# SETTLERS RANCH

## Filing No. 2C

# Construction Drawings

## El Paso County, Colorado

SETTLERS RANCH RD.  
PLAN & PROFILE  
(STA: 22+00 TO STA: 34+00.00)

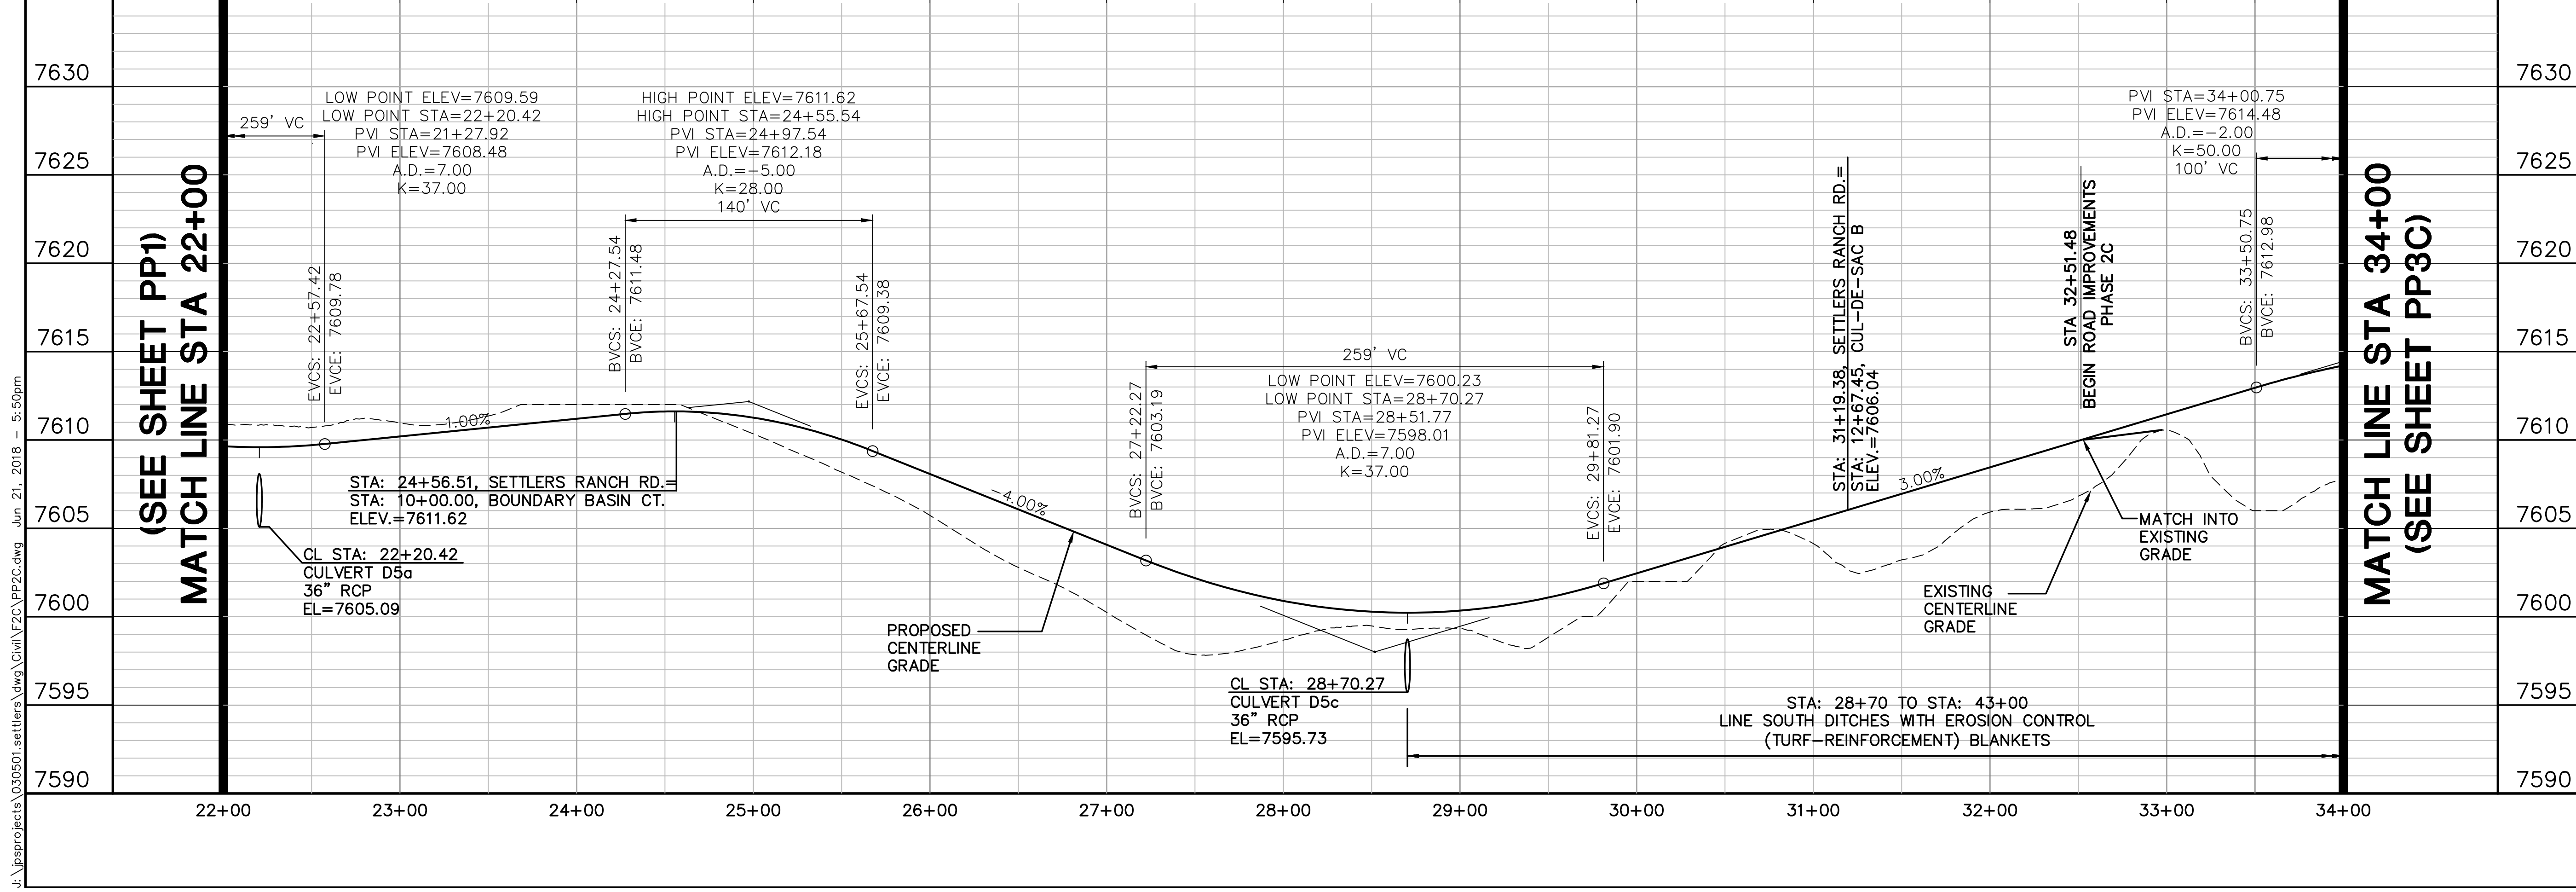
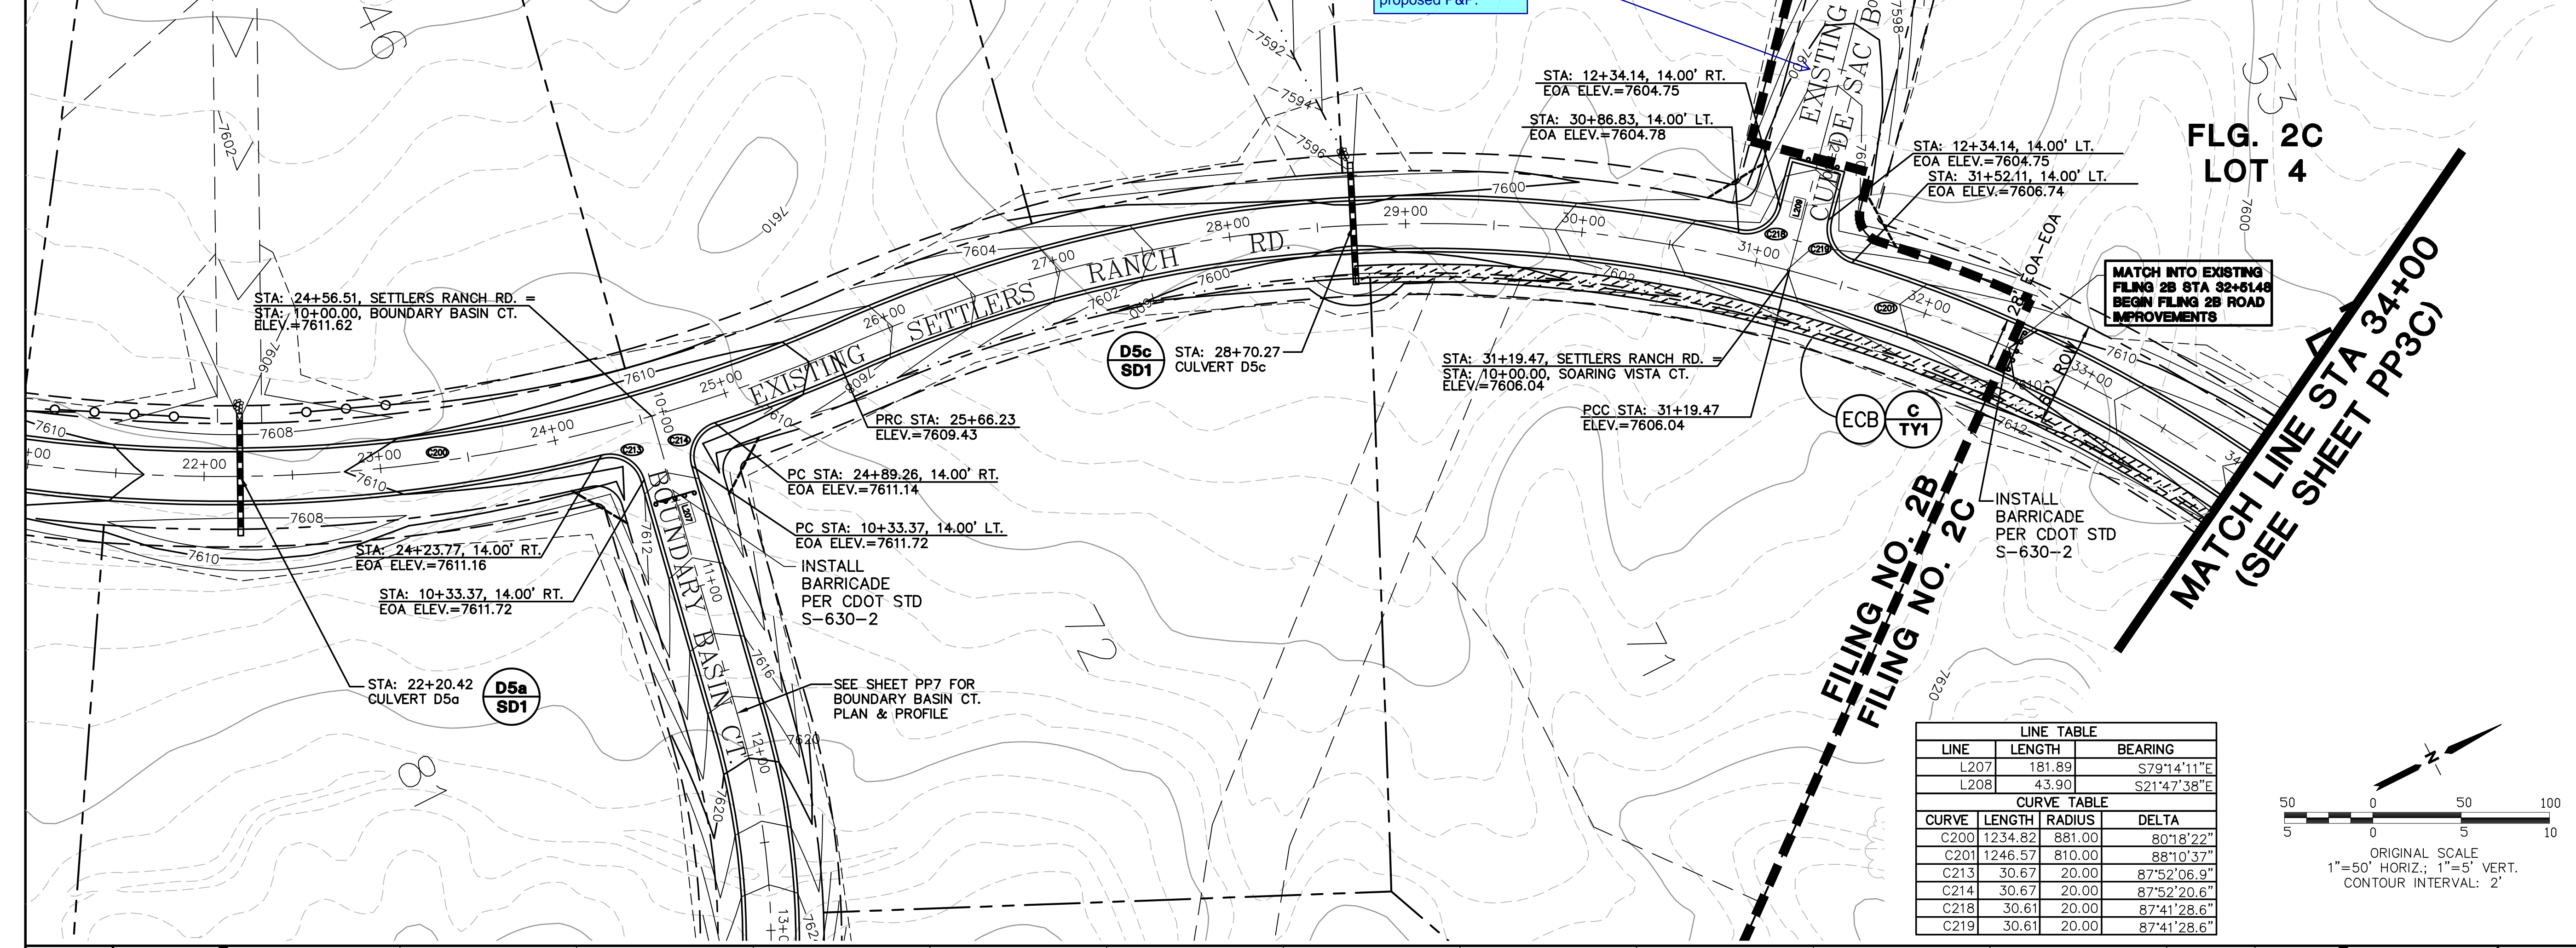
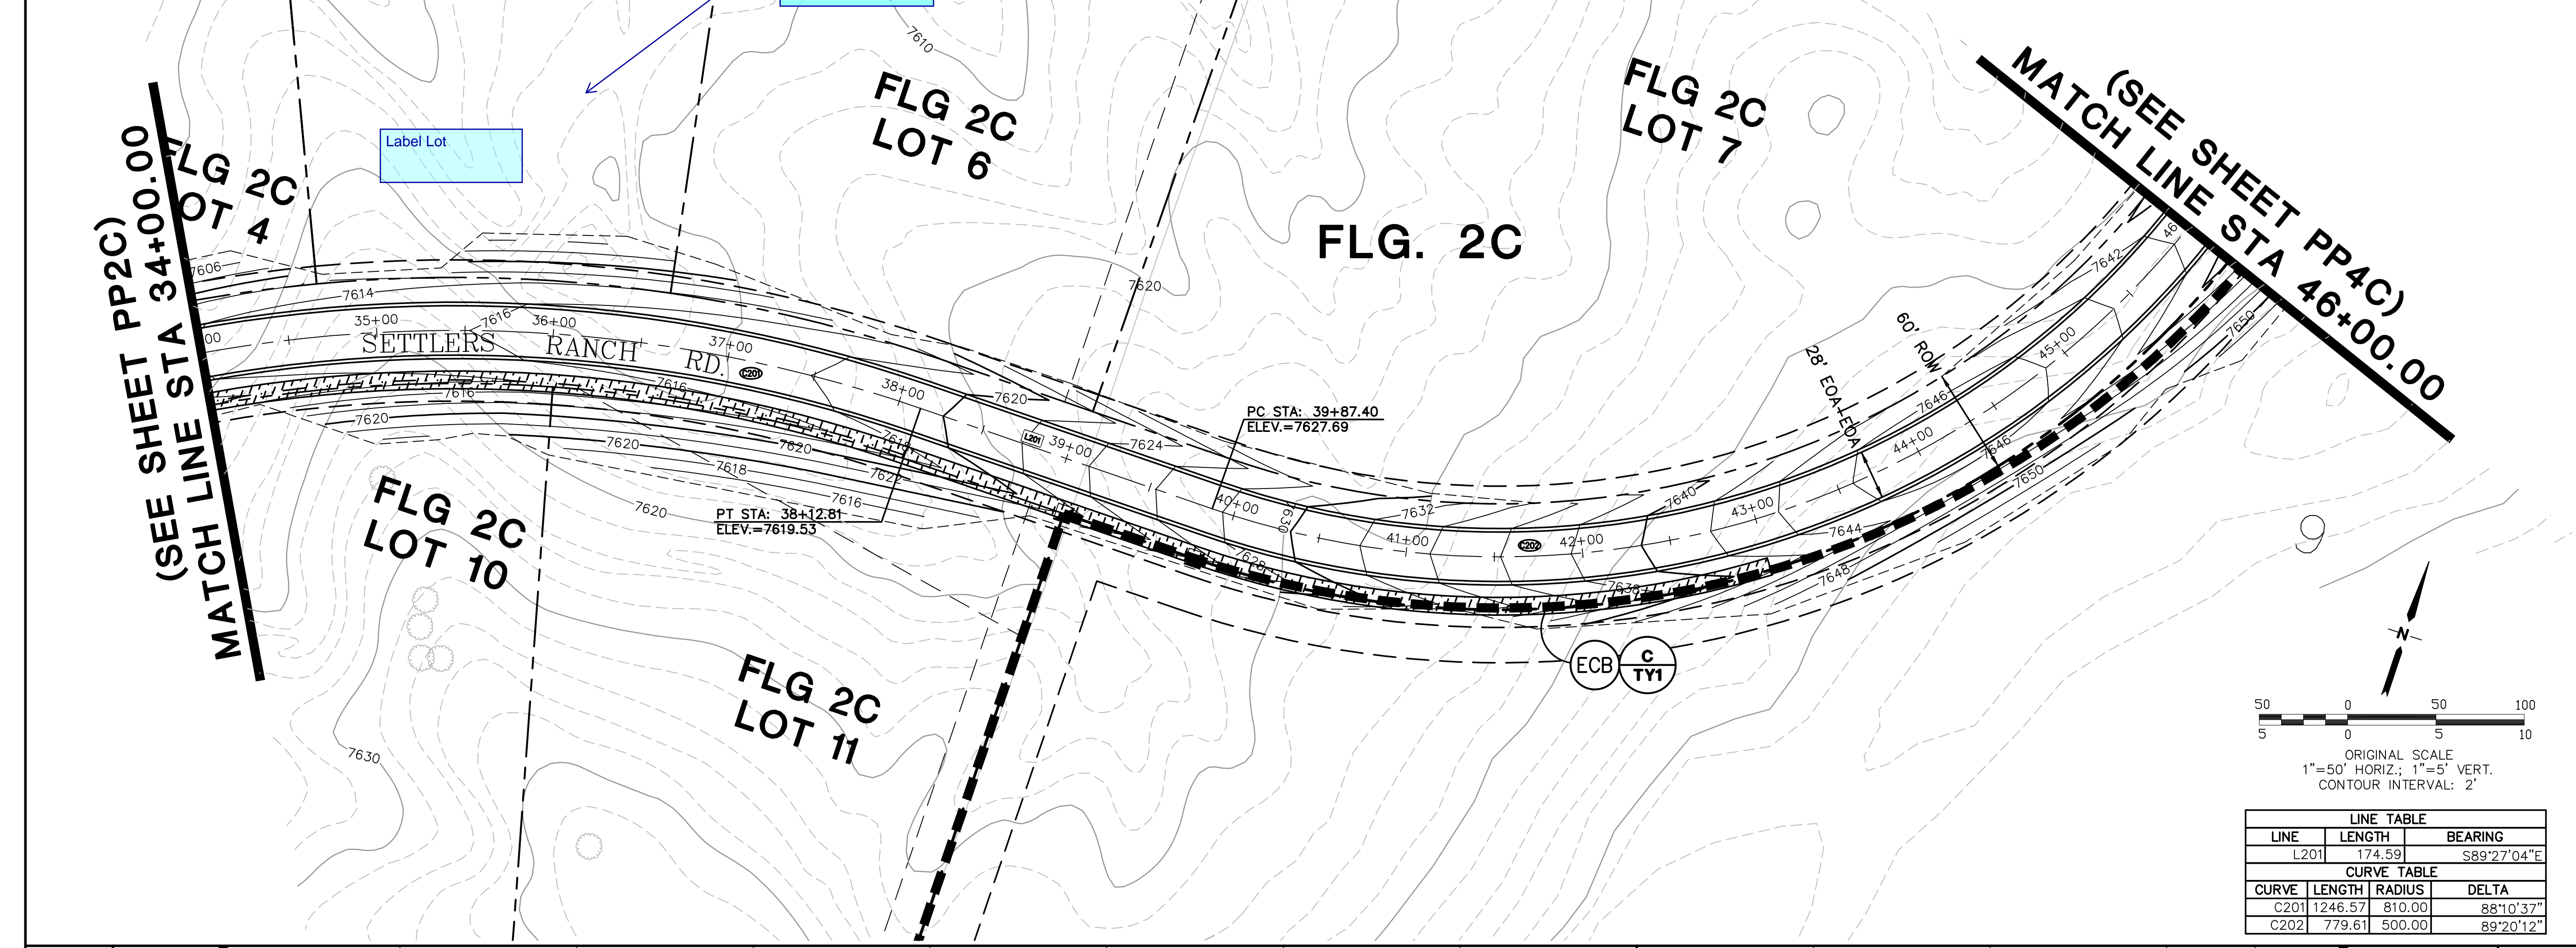
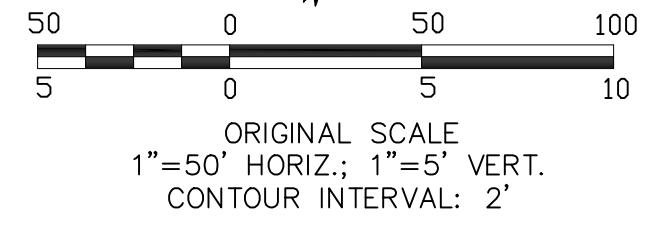
Show and label all proposed drainage and slope easements identified in the plat.

Label Lot
